# Staff Report

To: Salt Lake City Planning Commission  
From: David J. Gellner, AICP, Principal Planner; (801) 535-6107; [david.gellner@slcgov.com](mailto:david.gellner@slcgov.com)  
Date: February 28, 2018  
Re: PLNSUB2017-00962 – The Mabel Townhomes Planned Development

## PLANNED DEVELOPMENT

SITE PLAN  
1"=20'-0"  
NORTH

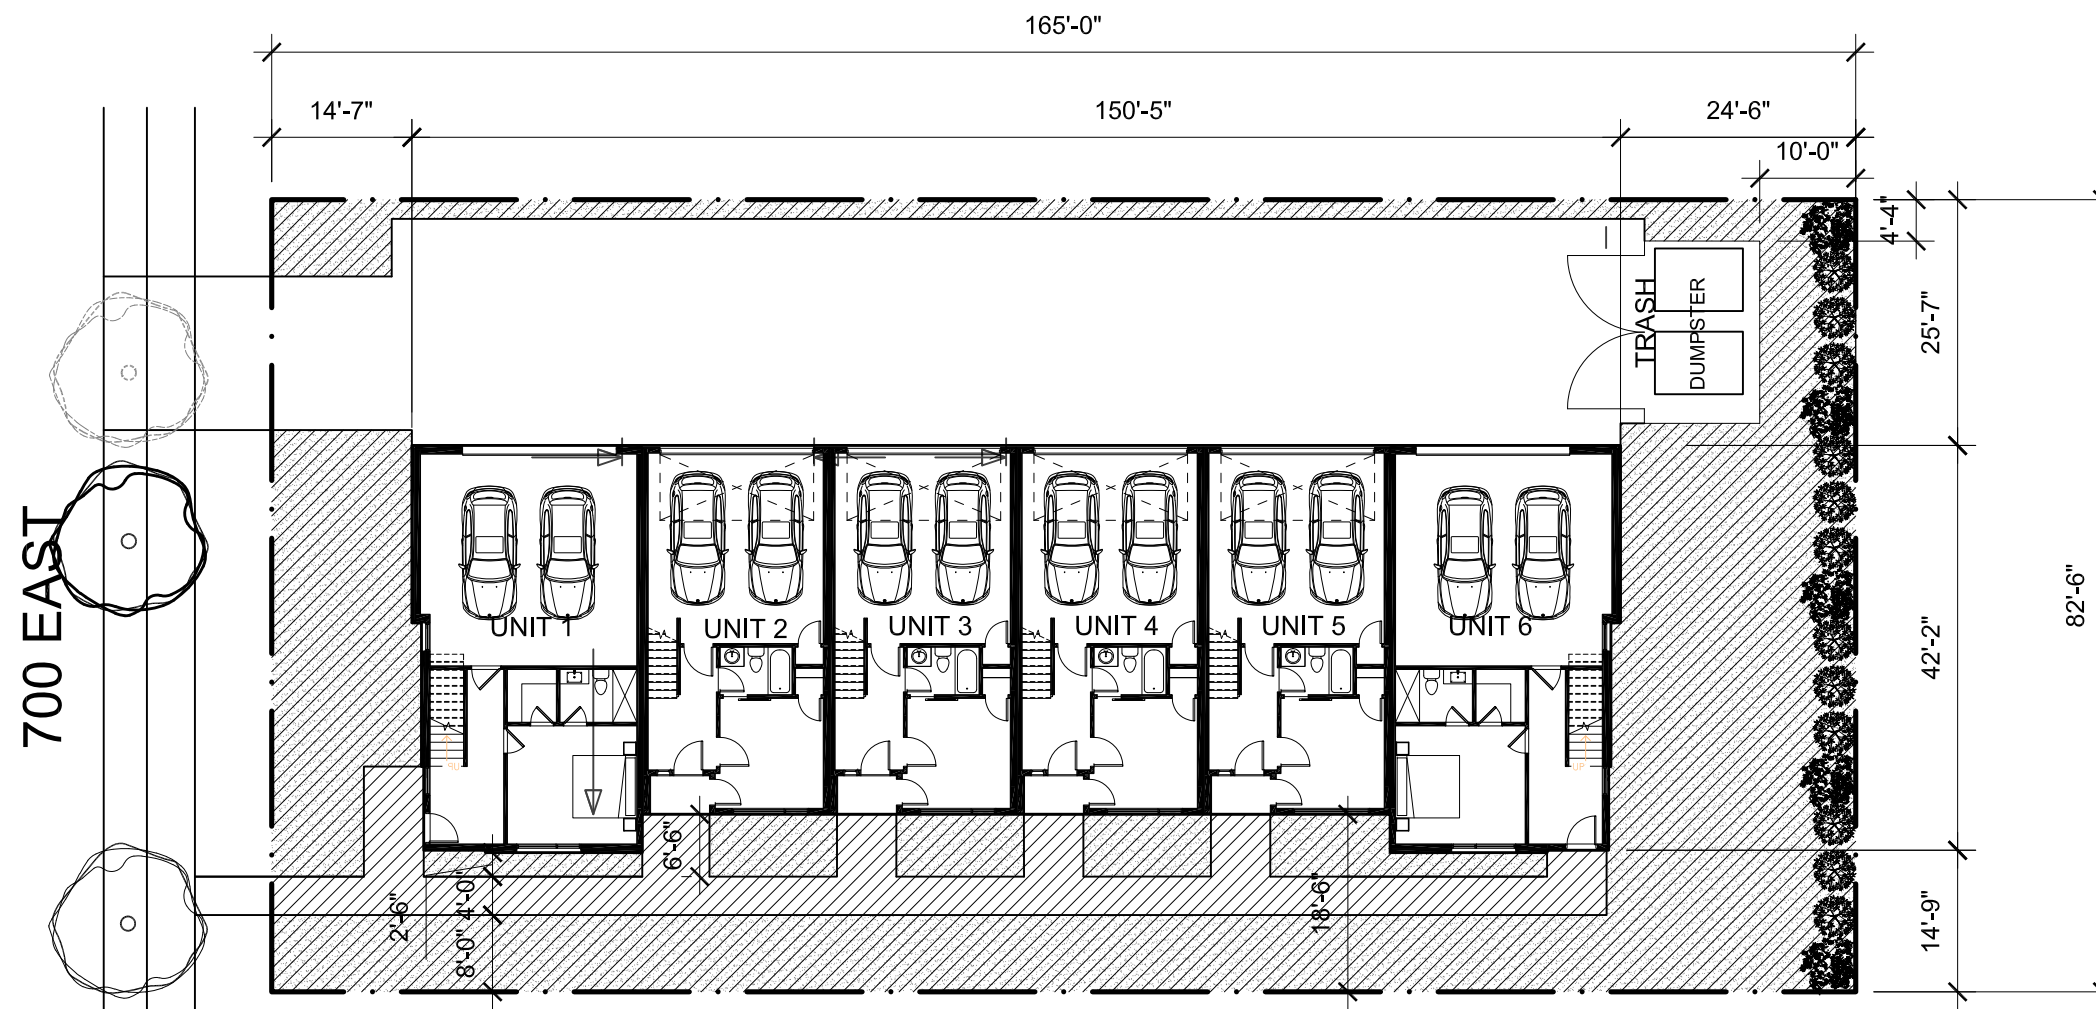
There is an existing 4" water main in 700 East. Each property currently has culinary water service. Only one culinary meter is allowed for the combined property. Unused water service must be terminated at the main. All improvements must comply with SLCPU standards and policies.

No objections to the proposed planned development. 700 East at this location is a city street. No involvement from UDOT is needed for the proposed drive approach or street trees, if any.

The setback will be compatible with the existing park strip trees. The park strip trees will need to be protected throughout all phases of demolition and construction.

- A demolition permit will be required for the removal of the existing building (see 18.64 for demolition provisions). As part of the demolition application, the construction waste management provisions of 21A.36.250 apply.

- This proposal will need to comply with any appropriate provisions of 21A.40 and including ground mounted utility boxes – the provisions of 21A.44 for parking and maneuvering, with parking calculations provided that address the minimum parking required, maximum parking allowed, number provided, bicycle parking required/provided and any method of reducing or increasing the parking requirement - the provisions of 21A.48 for landscaping and including the landscape buffer along the property line abutting the SR-3 zoning district.

The proposed Multi-family attached condo project for six (6) units on 2 parcels, with a three story structure less than 30 feet tall, with no public street frontage parallel to one entire side, with a driveway greater than 150 feet in length and hand line fire hose access greater than 150 linear feet to all exterior walls; shall be provided with a fire sprinkler system with an increase in density (minimum 0.05 over square feet), with an enhanced fire alarm system for early detection and a physical barrier with signs not exceeding 150 feet measured from the lip of the public roadway on 700 east, or a fire truck turn around shall be provided for the private driveway. The proposed development will require an approved Alternate Means and Methods (AM&M) agreement by Fire Prevention Bureau (FPB) prior to any permit issuance with a scaled site plan clearly showing the property lines and the place of any proposed structure on the parcel(s).
